**1958 Agreement – Consideration of draft amendments  
to existing Regulations submitted by GRE**

### **Proposal for Supplement 8 to Regulation No. 104 (Retro-reflecting markings)**

#### **Submitted by the Working Party on Lighting and Light-Signalling\***

"Figure 3.

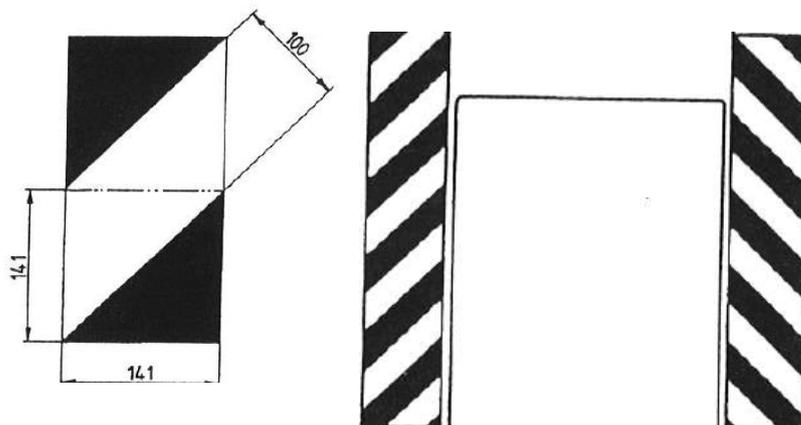
2.2.1. Class F retro-reflective materials shall consist of red and white diagonal stripes each 100 mm wide sloping outwards and downwards at 45°. The basic standard area is a square of 141 mm in length subdivided diagonally into a white half and red half, which represents one standard area as shown in Figure 3.

2.2.2. The minimum length of an element of a retro-reflective marking material shall incorporate a minimum of 9 standard areas as described in paragraph 2.2.1. above on large vehicles with available mounting space, but may be reduced to a minimum of 4 standard areas on vehicles with limited mounting space."

Insert a new figure 3, to read:
